## **Certificate of Appropriateness**

Property Description of	<b>2017 N Terrace Avenue</b> Construct an 11'8" by 13' second floor wood balcony/jump porch on a north façade of
work	the house that is primarily visible from the east side of the house. Remove existing rotted balcony, excavate two 16" round footings four feet below grade. Cover steel
	and iron beams with wood boards. Install aluminum flashing between existing house and new balcony.
Date issued	4/6/2022 PTS ID N/A

SIDE VIEW OF DECK (JUMP FORCH)

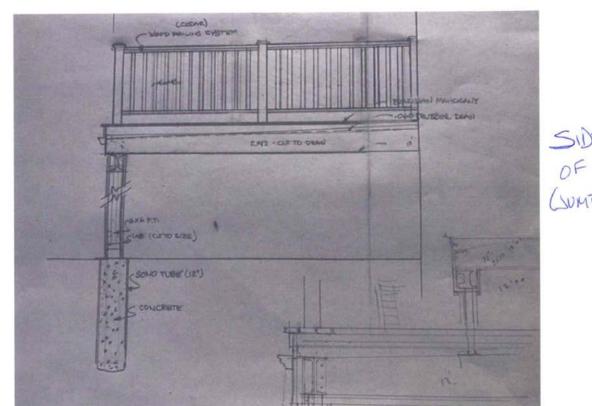
Railing system balusters must be spaced no more than 3.5 inches apart.

Paint wood to match existing trim and/or siding.

All finish wood must be smooth and free of knots and must be painted or treated with an opaque stain upon completion. Note: when new, bare wood is left exposed to the exterior elements for a period of only a week or two, the life the of the paint job subsequently applied to it will be decreased. The use of a naturally decay-resistant wood species for exterior finish applications is required for porch areas. Using western white pine or Ponderosa pine is "at your own risk" because this wood has no natural decay resistance and can deteriorate in some exterior settings in just a few years.

Porch drawing approved with conditions
